February 07, 2025

**ADDENDUM NO. 3
TO THE
CONTRACT DOCUMENTS
FOR
CUMBERLAND COUNTY TRANSFER STATION**

- AD3-1. Revised Site Civil Drawings
- AD3-2. Revised Bid Form

DESIGNED: J.D.B.	PROJECT NO: CUMBERLAND 22-1
DRAWN: J.R.T.	SCALE: AS SHOWN
APPROVED: S.A.S.	DATE: DEC. 2024
FILENAME: CUMBERLAND-D0262	
SHEET NUMBER: 2	DRAWING NUMBER: S1

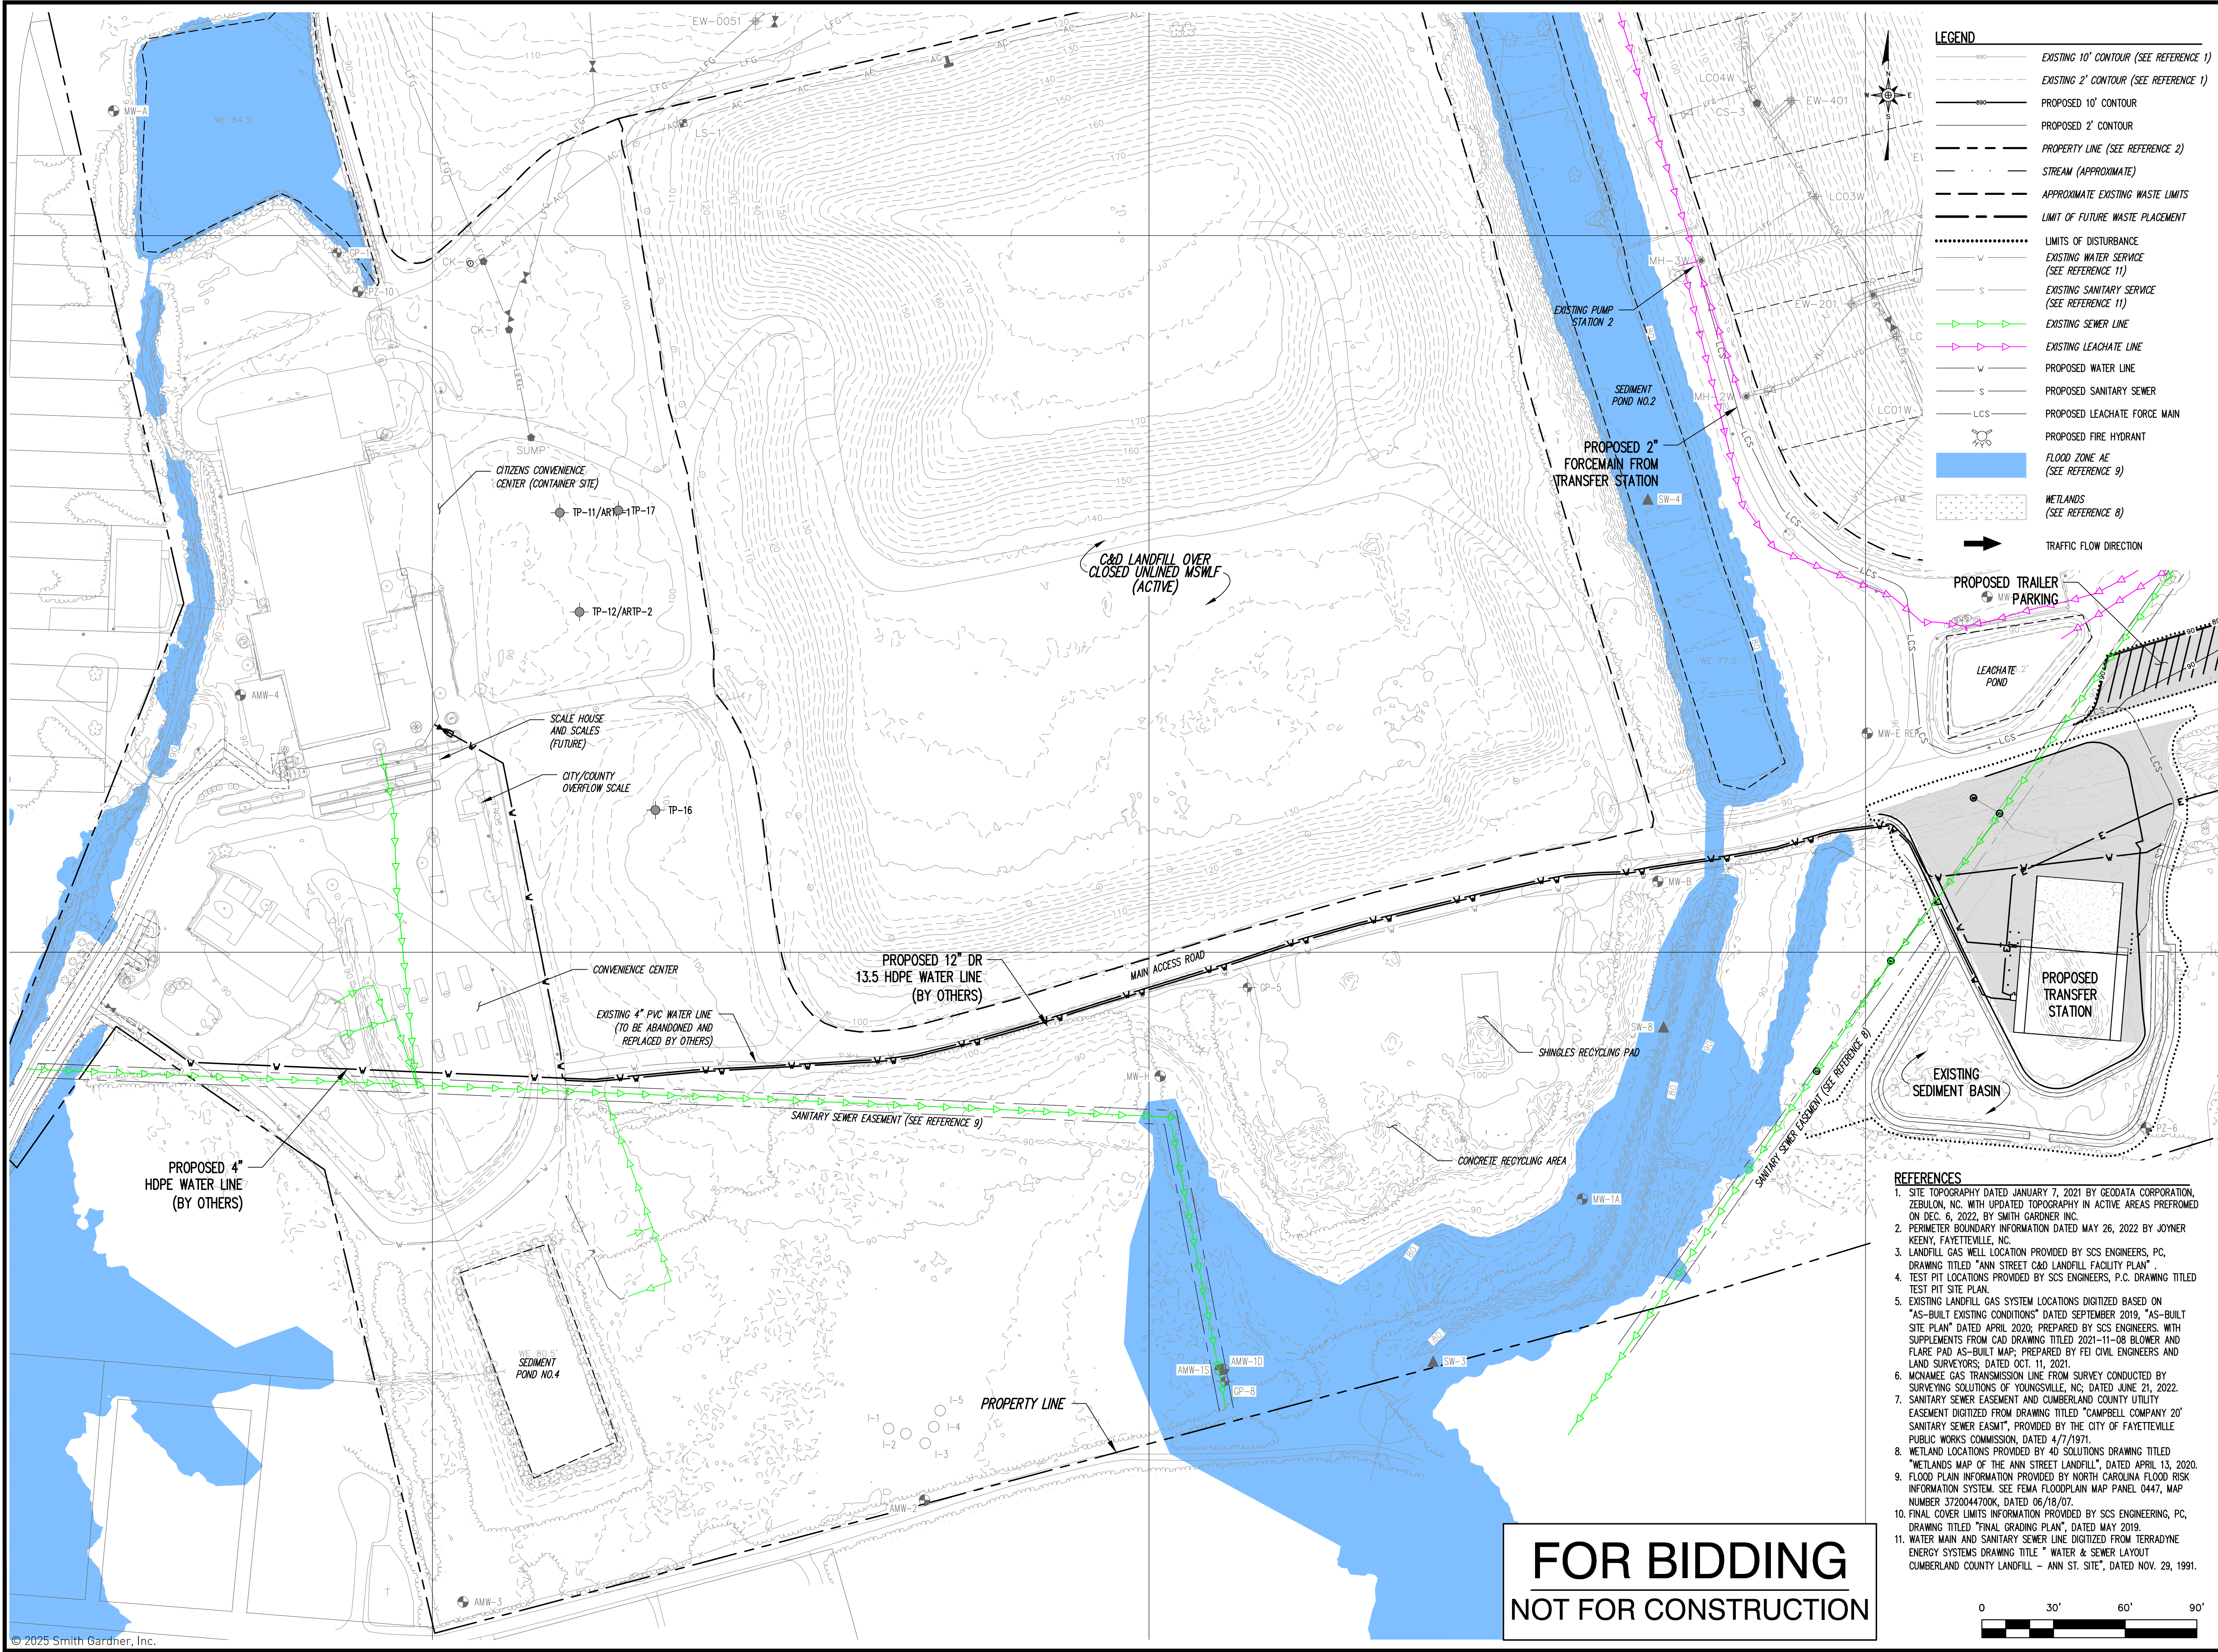
- AD3-8. *The existing conditions S1 drawing indicates some additional topo lines at the proposed transfer station site location that are not defined – please confirm these topo elevations. Also, please confirm the topo elevation of the existing leachate pond/skimmer basin.*

Additional topo line has been removed. Topographic information depicted on the pad is existing as of 12-12-24. Contractors to assume the existing sediment pond (not leachate pond)/ skimmer basin is in accordance with proposed elevations as indicated.

DESIGNED: J.D.B.	PROJECT NO: CUMBERLAND 22-1
DRAWN: J.R.T.	SCALE: AS SHOWN
APPROVED: S.A.S.	DATE: DEC. 2024
FILENAME: CUMBERLAND-D0263	DRAWING NUMBER:
3	S2

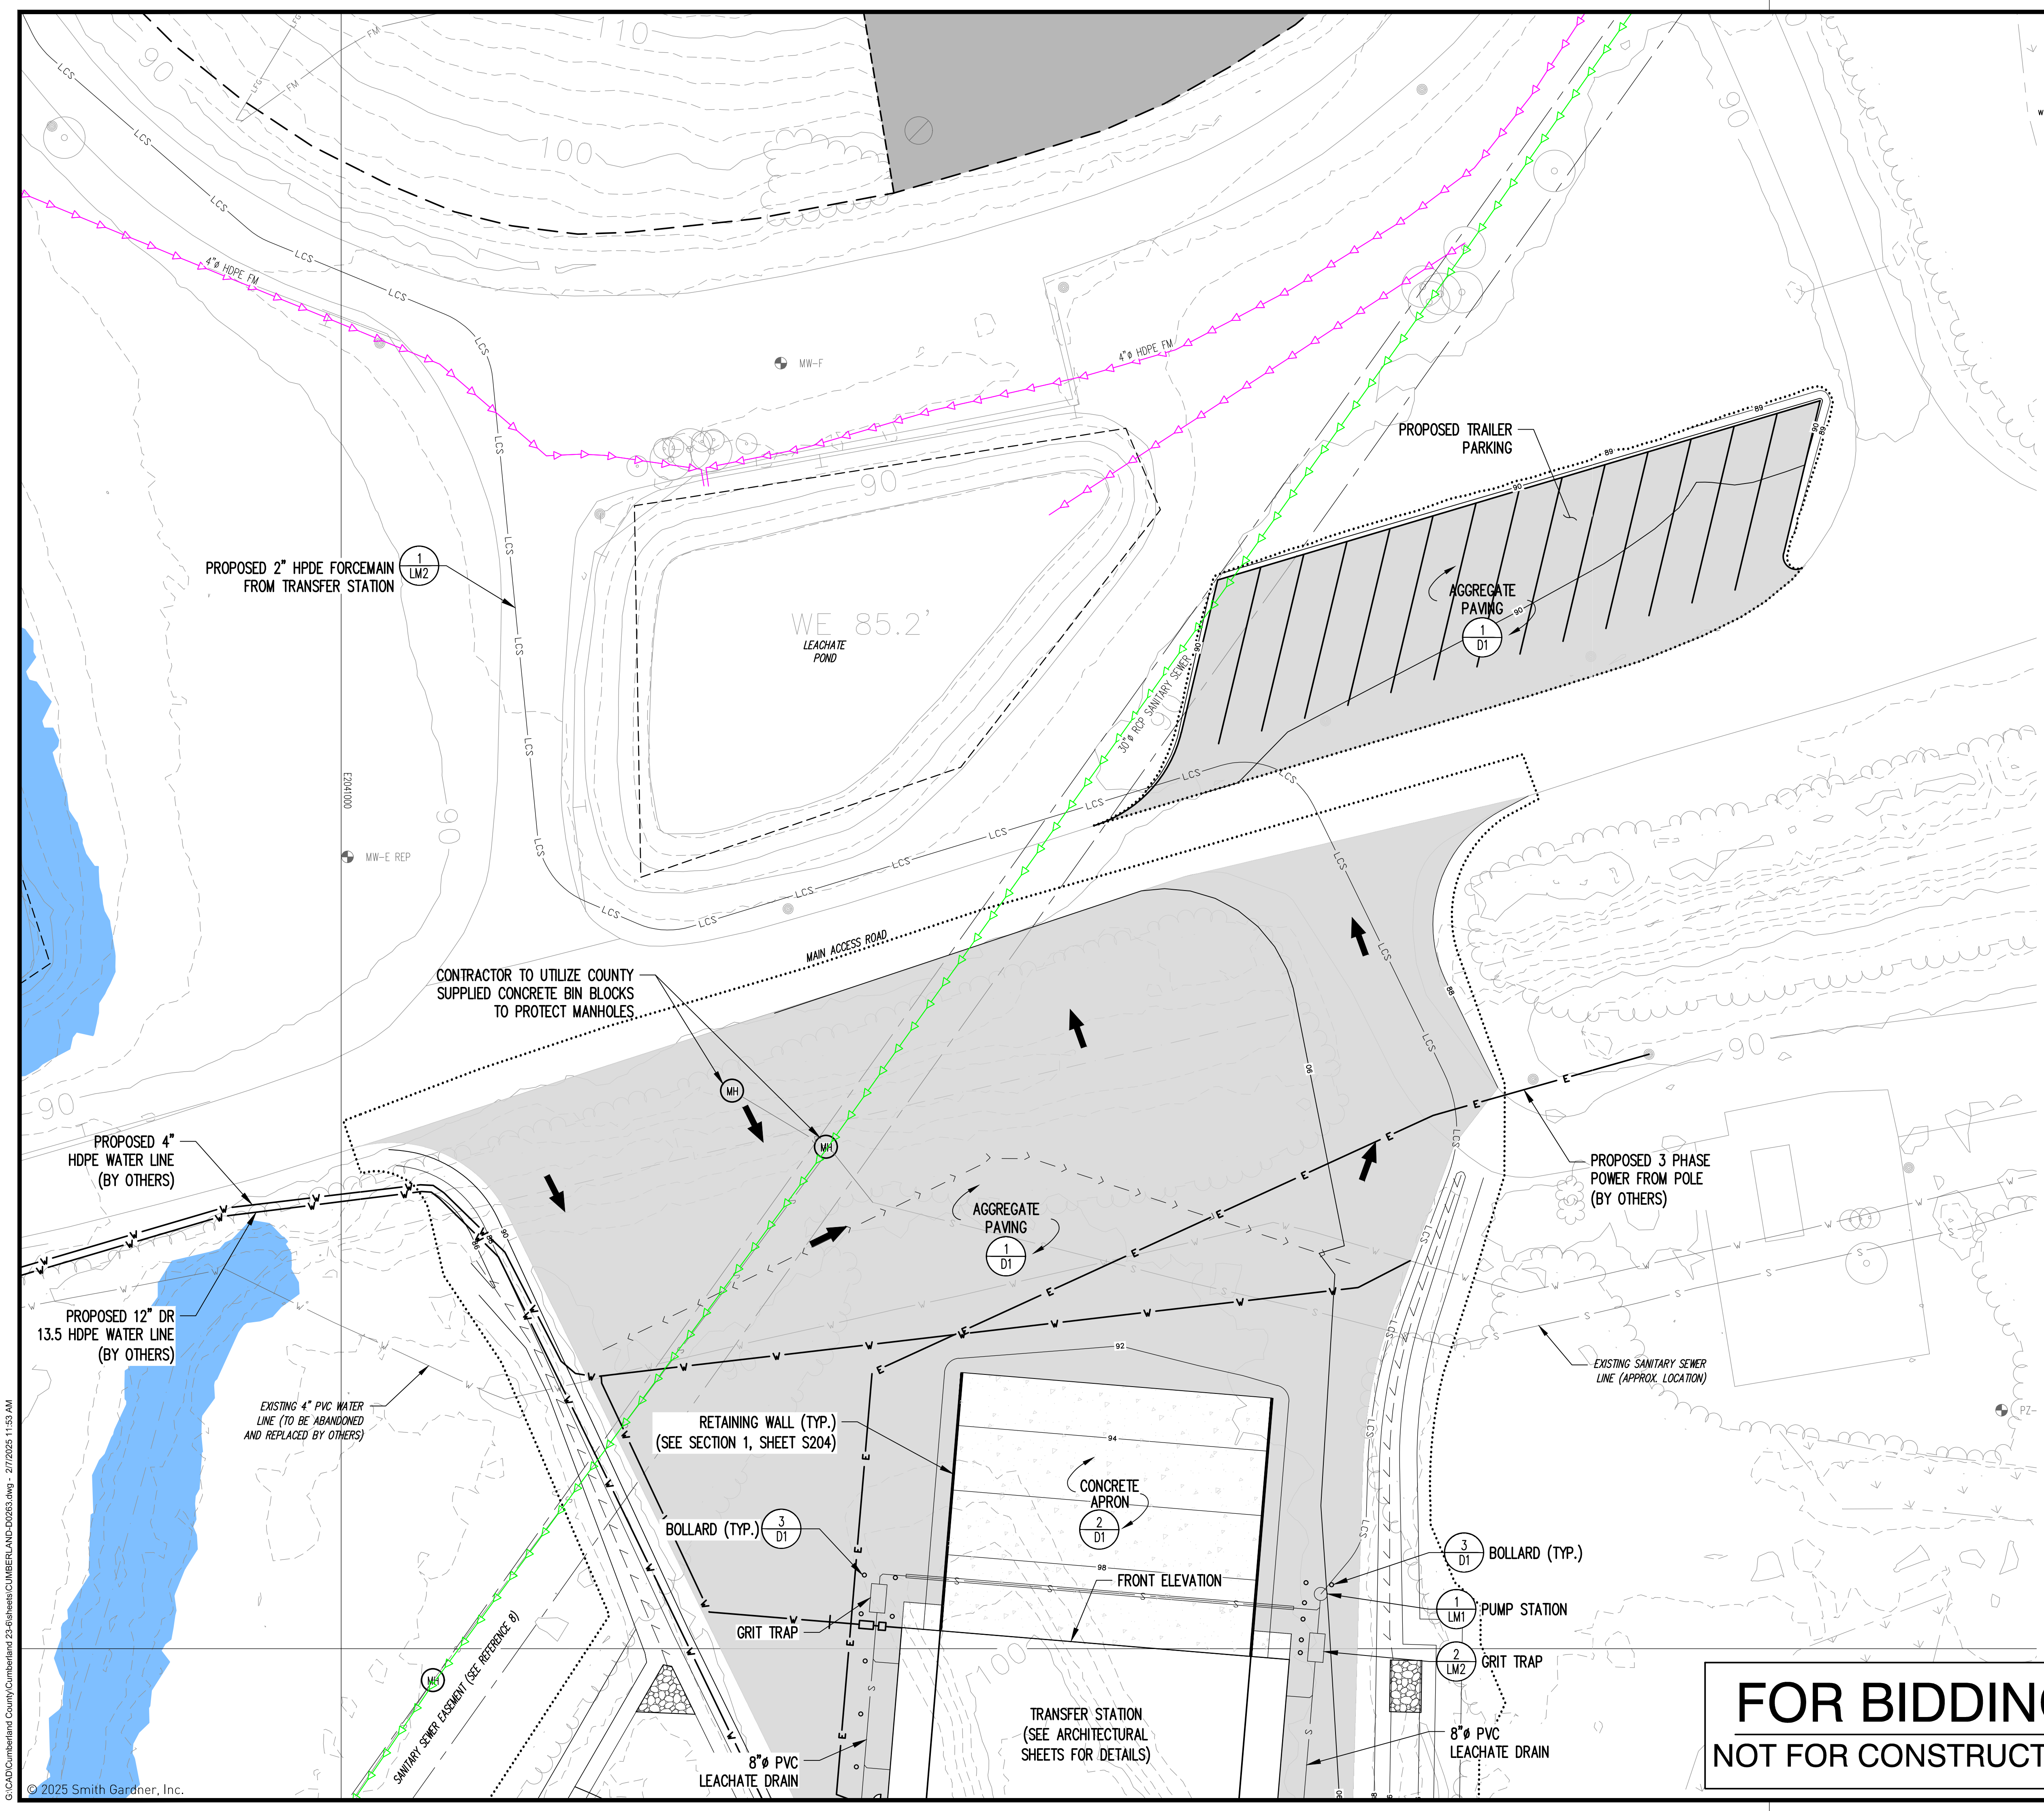
Please clarify the limit of disturbance as the Drawing S3 shows one line around the transfer station and another is around the existing sediment basin. Is any site work required in the sediment basin area to include temp silt fence, drainage channels, etc.? Please advise.

AD3-35. *Please clarify the limits for the proposed aggregate paving. Drawings S3, S4 and S5 do not specifically depict limits of aggregate paving. The gray shaded areas appear to represent Flood Zone AE.*

The limit of disturbance has been revised. See attached revised civil drawings.

See revised Drawings.

DESIGNED: J.D.B.	PROJECT NO: CUMBERLAND 22-1
DRAWN: J.R.T.	SCALE: AS SHOWN
APPROVED: S.A.S.	DATE: DEC. 2024
FILENAME: CUMBERLAND-020263	
SHEET NUMBER: 5	DRAWING NUMBER: S4

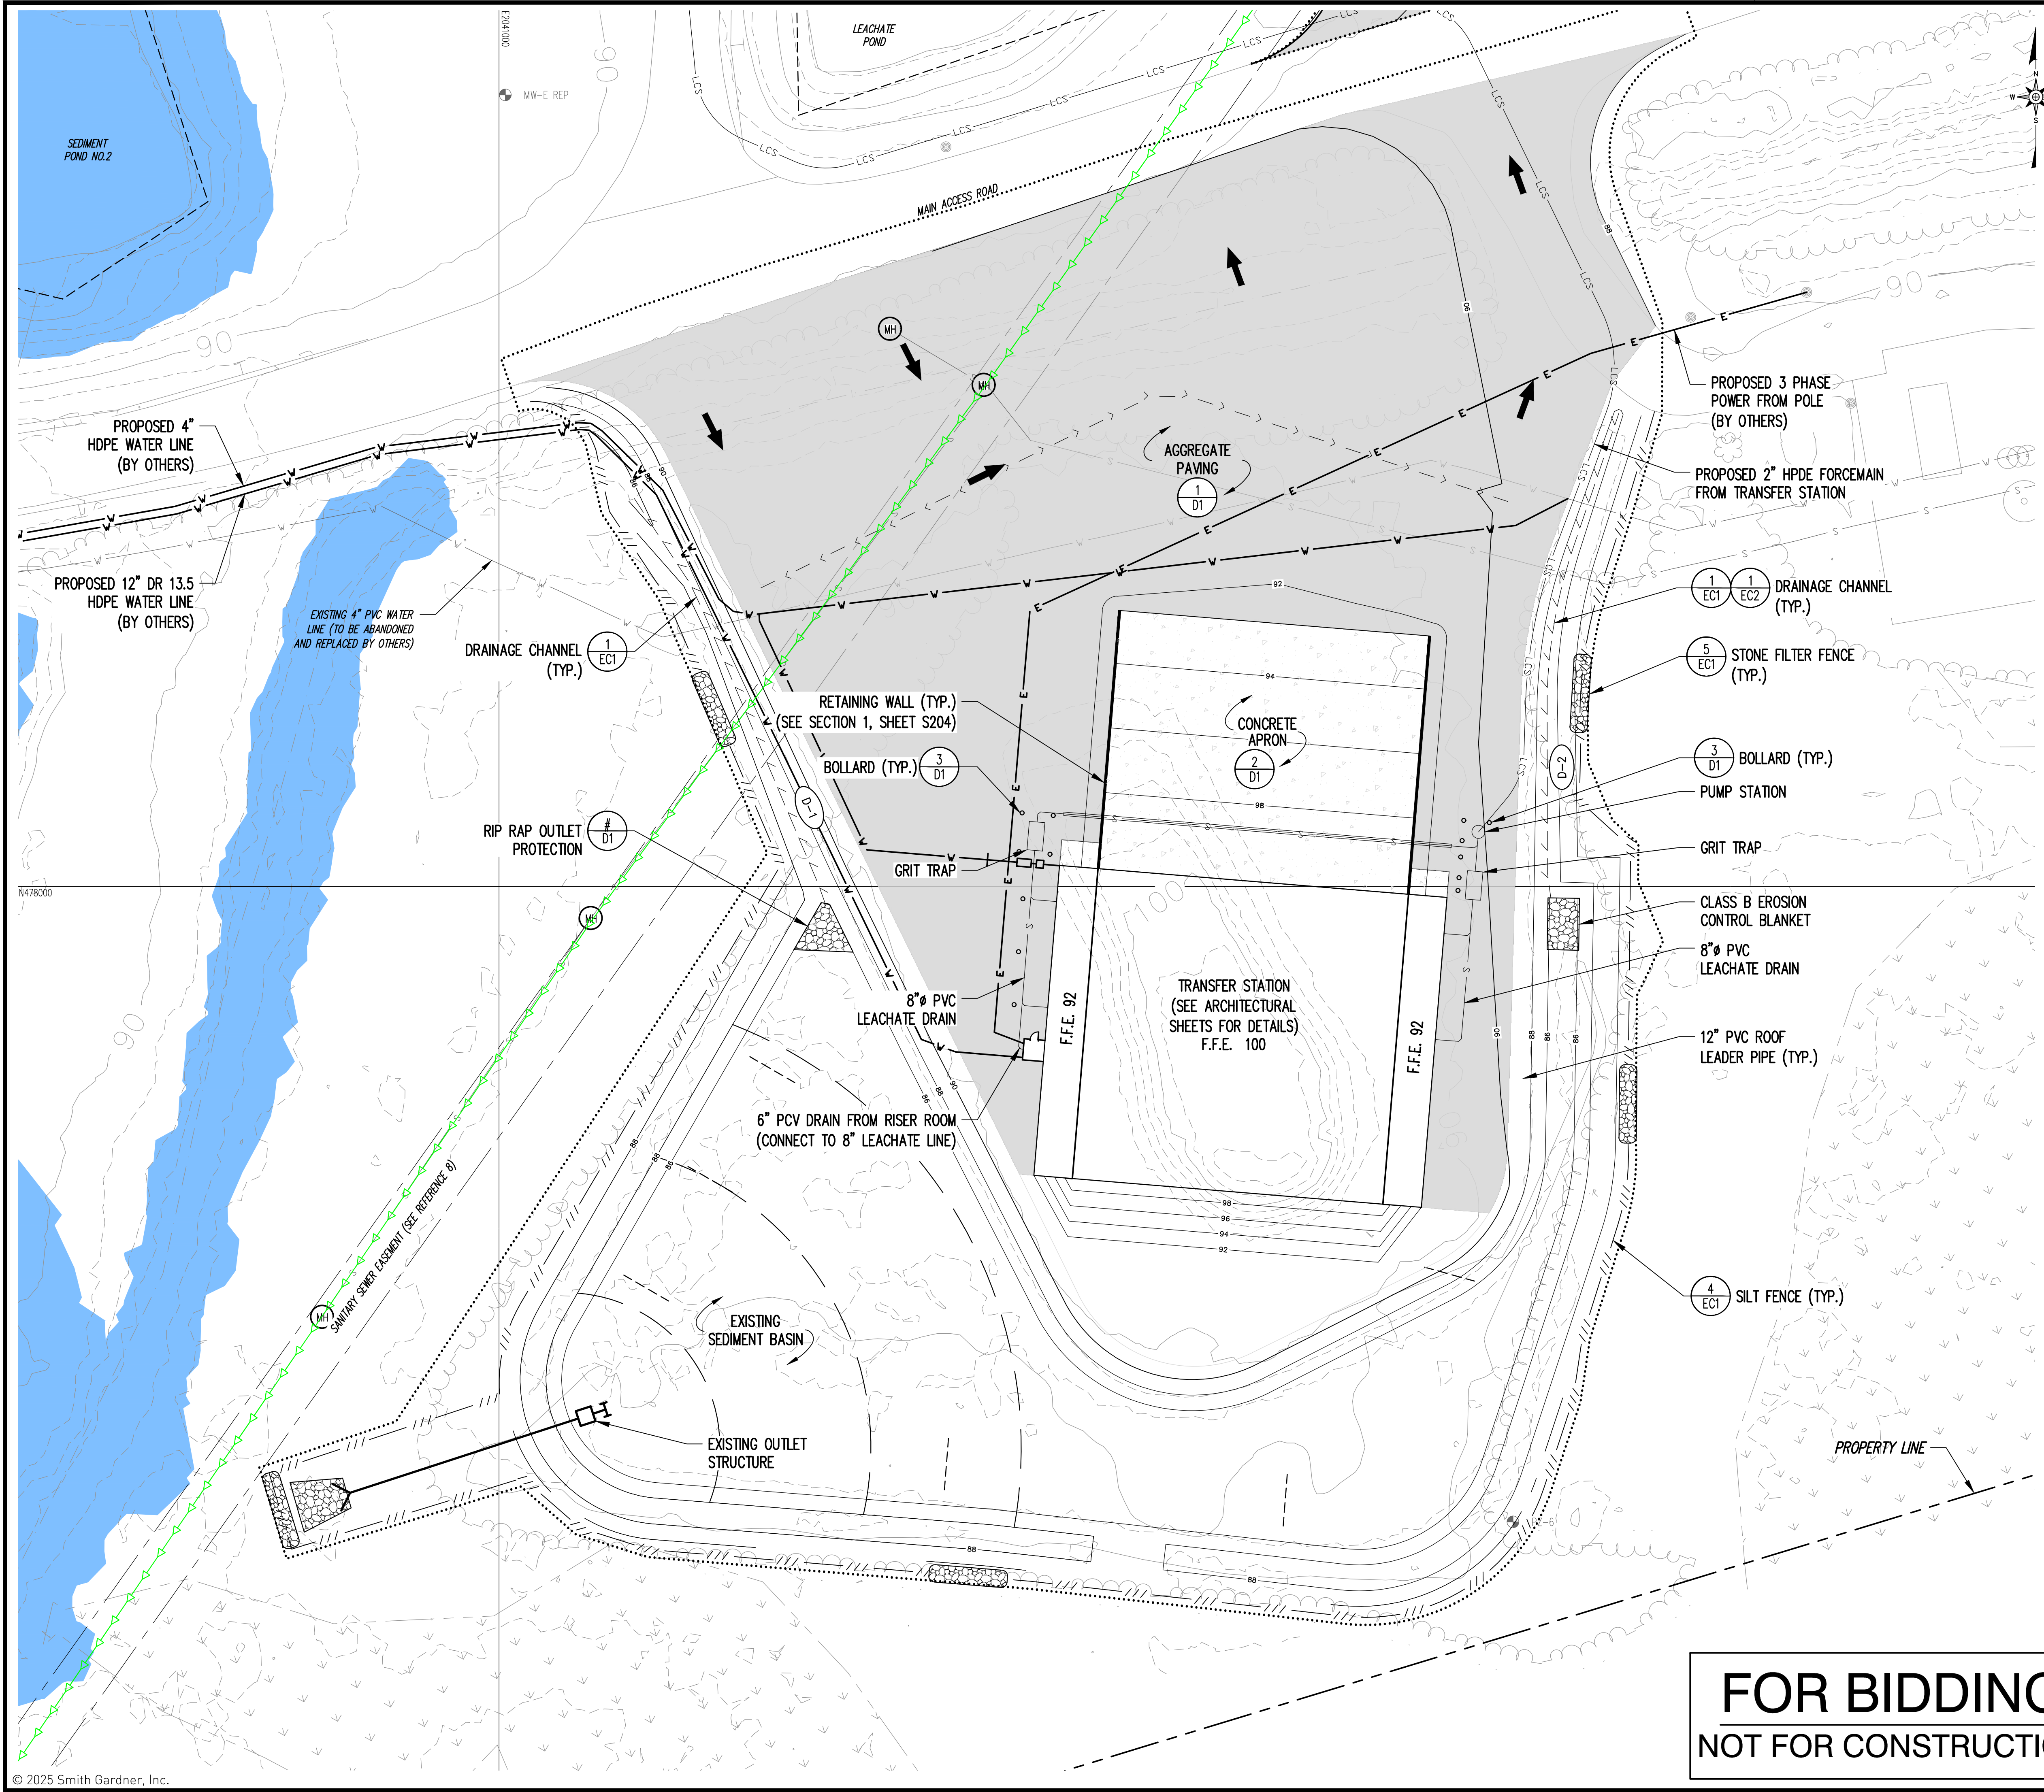
- AD3-21. *Please provide proposed grades/contours for the trailer parking area. Drawing S2 and S4 where this parking lot is shown does not provide this information.*

Grading has been added. See attached revised civil drawings.
